NOTICE OF DENIAL

RE: Application Number 20-6718; 729 Seward Avenue, New Center Area Historic District

CERTIFICATE OF APPROPRIATENESS

RE: Application Number 20-6718; 729 Seward Avenue, New Center Area Historic District

WINDOW PROFILES

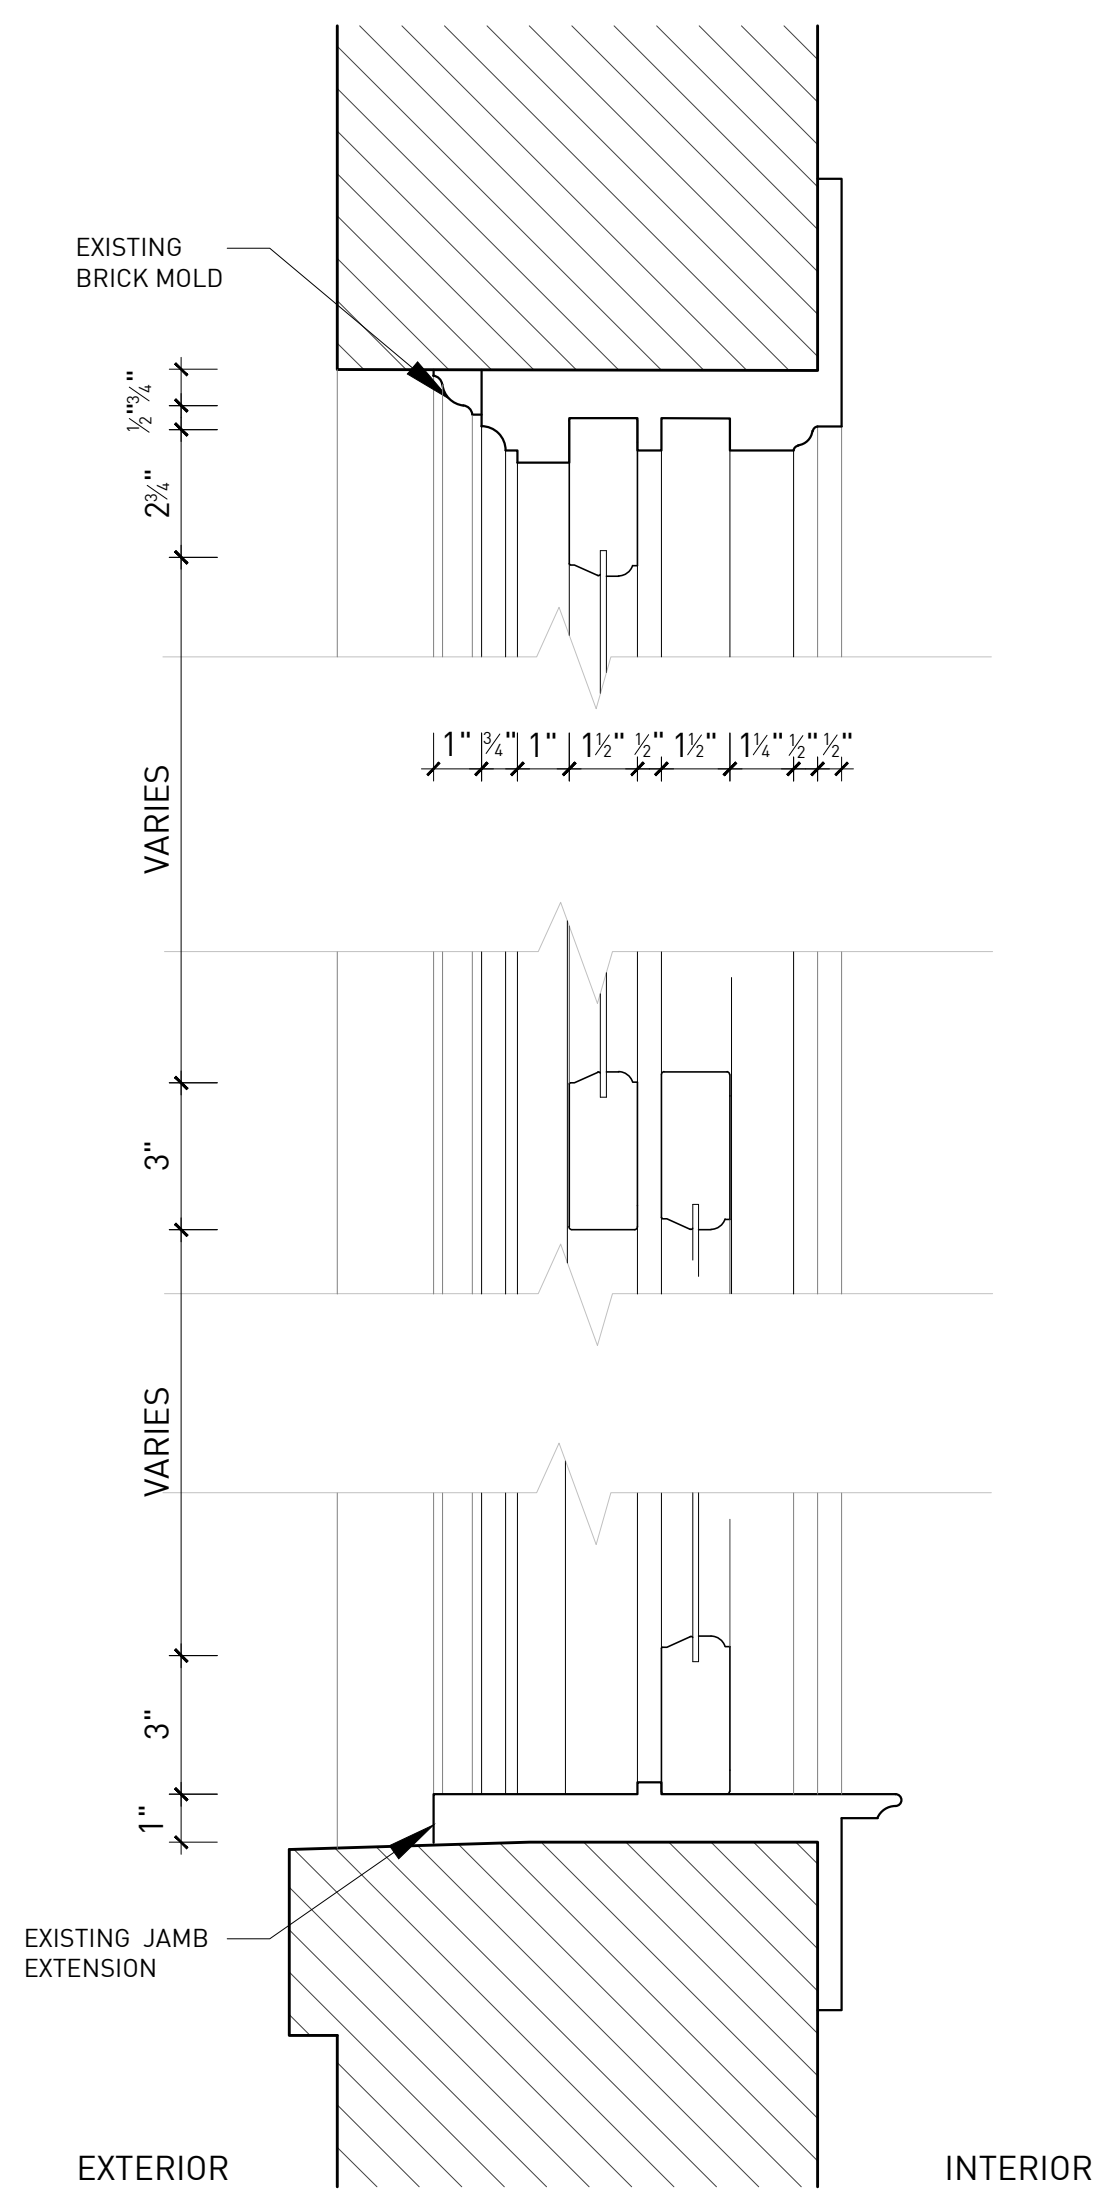
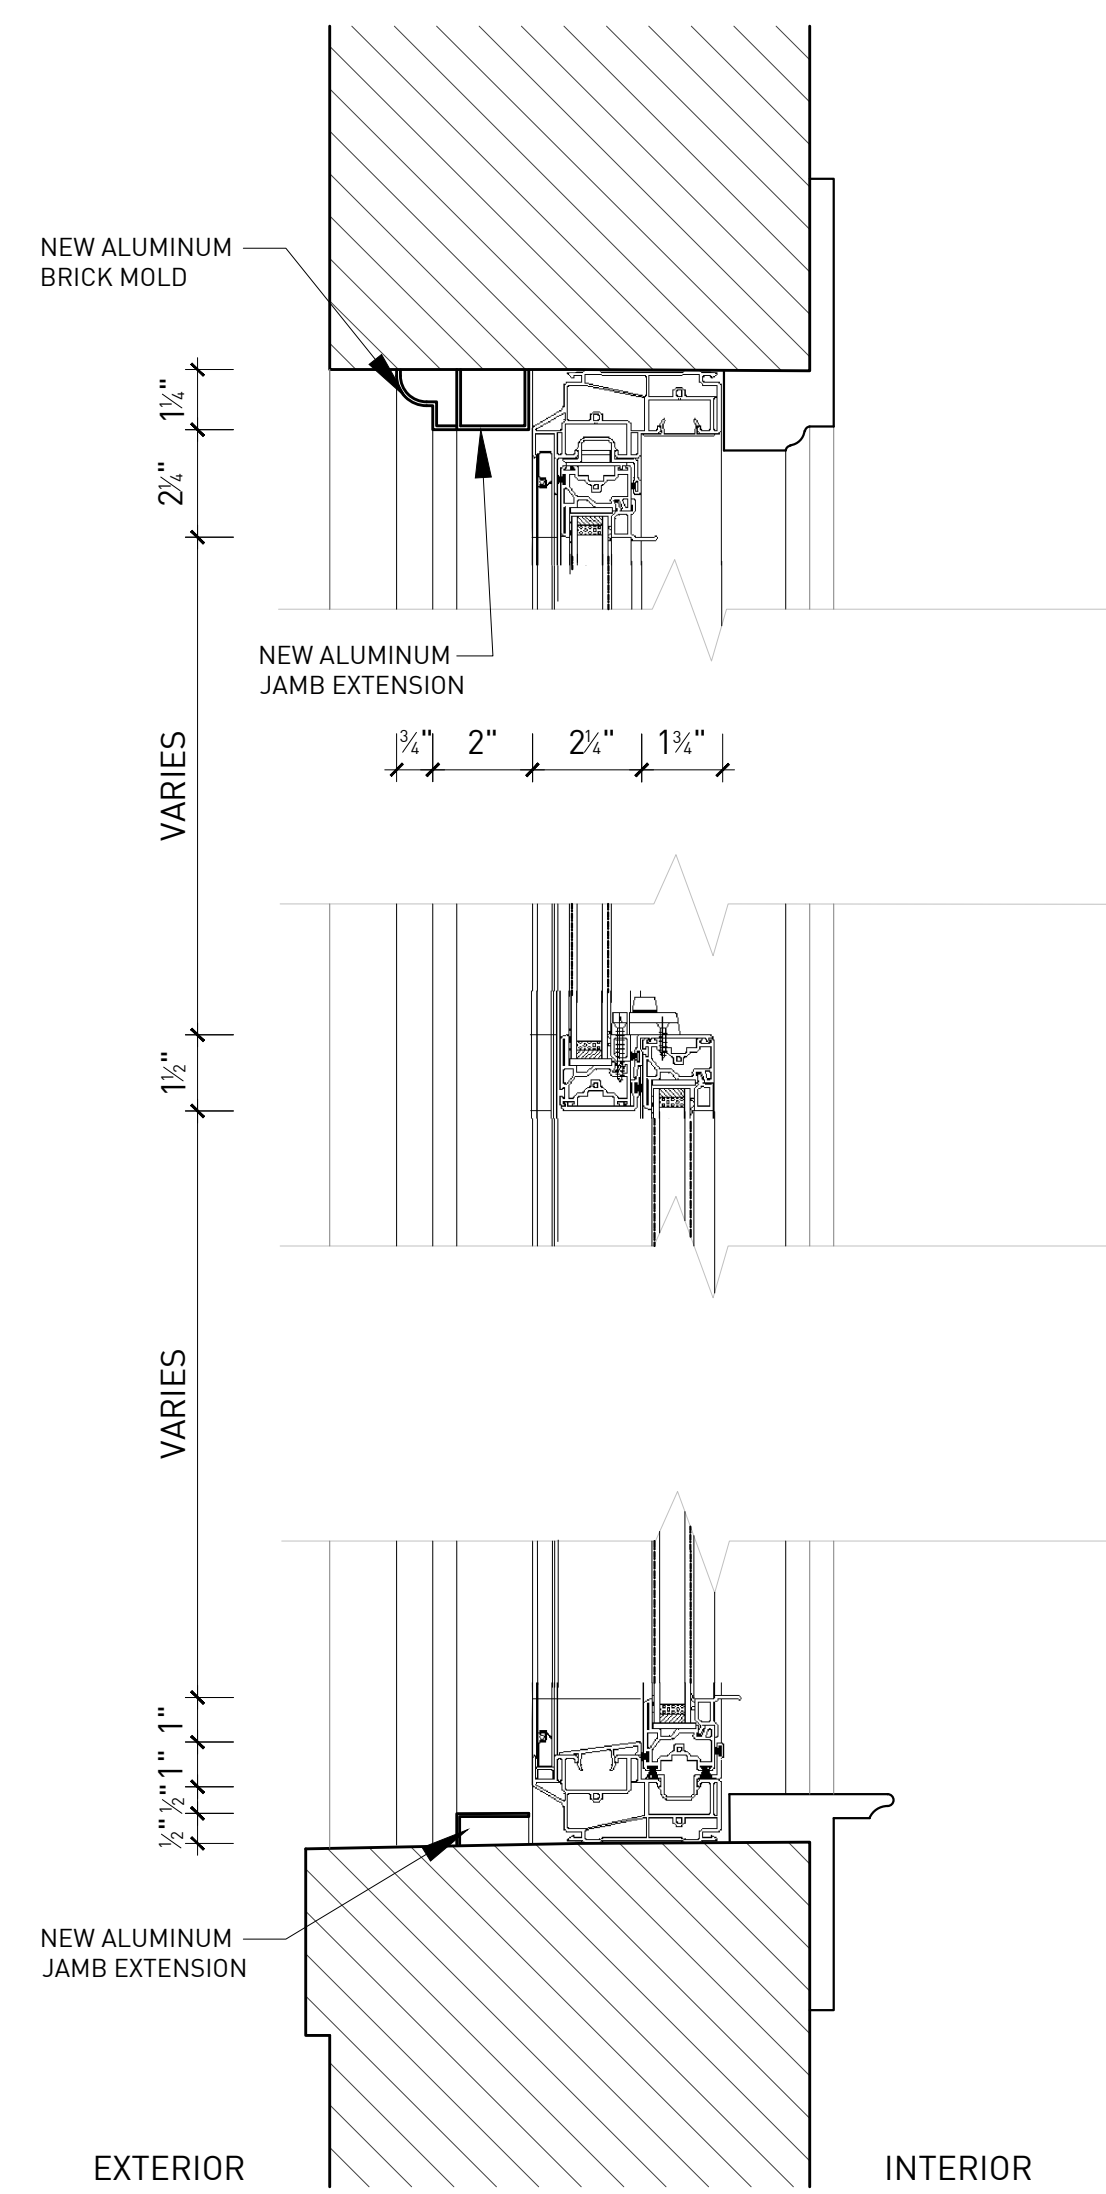
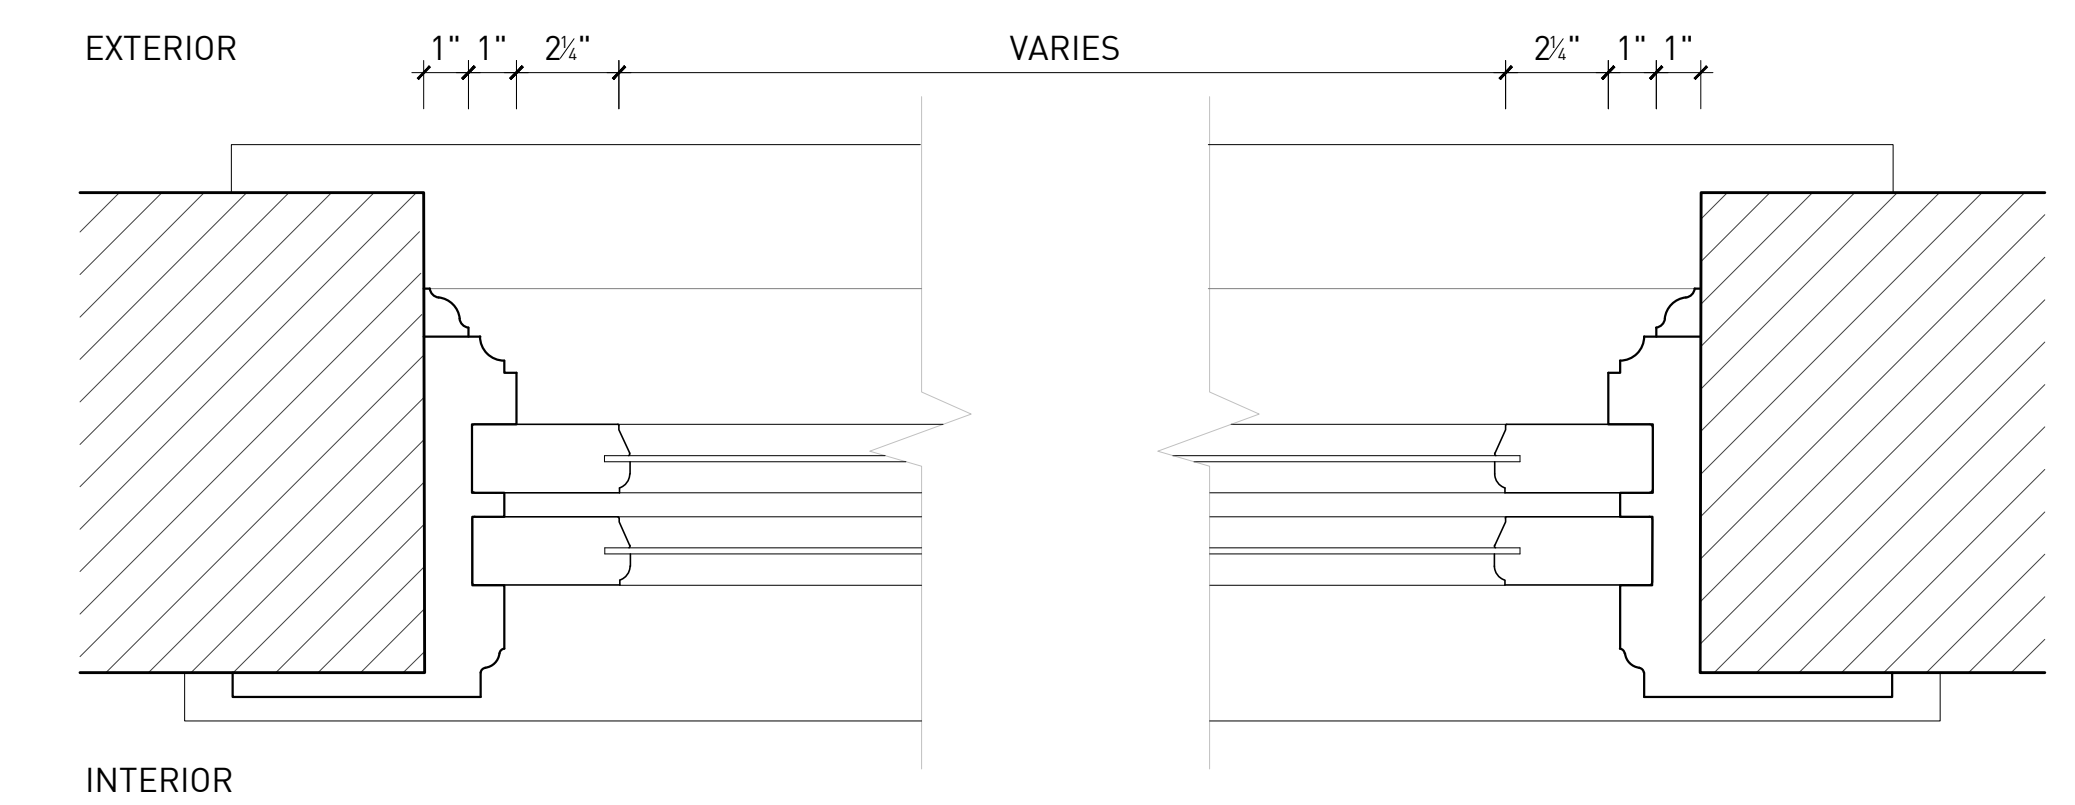
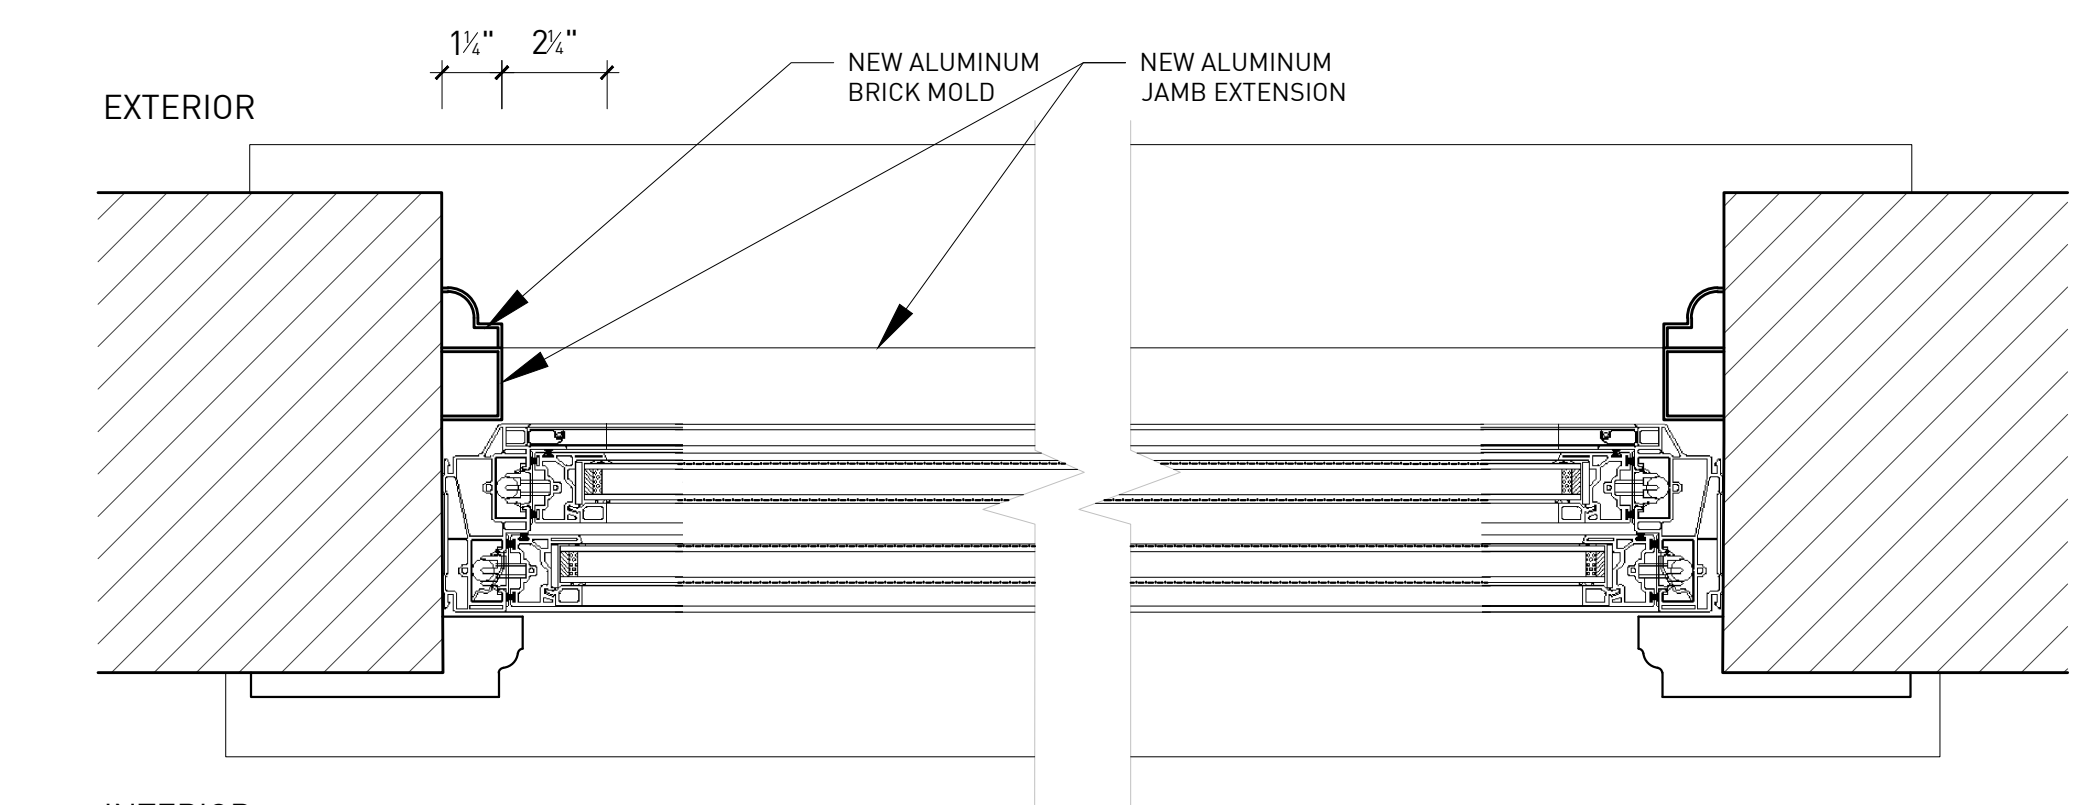
The replacement of the existing wood double-hung windows, trim, and brick mold with new double-hung vinyl units and trim, as proposed in the attached application, does not meet the Secretary of the Interior’s Standards for Rehabilitation, especially 2) *The historic character of a property shall be retained and preserved. The removal of historic materials or alteration of features and spaces that characterize a property shall be avoided;* 5) *Distinctive features, finishes, and construction techniques or examples of craftsmanship that characterize a property shall be preserved;* 6) *Deteriorated historic features shall be repaired rather than replaced. Where the severity of deterioration requires replacement of a distinctive feature, the new feature shall match the old in design, color, texture, and other visual qualities and, where possible, materials. Replacement of missing features shall be substantiated by documentary, physical, or pictorial evidence;* and 9) *New additions, exterior alterations, or related new construction shall not destroy historic materials that characterize the property. The new work shall be differentiated from the old and shall be compatible with the massing, size, scale, and architectural features to protect the historic integrity of the property and its environment.*
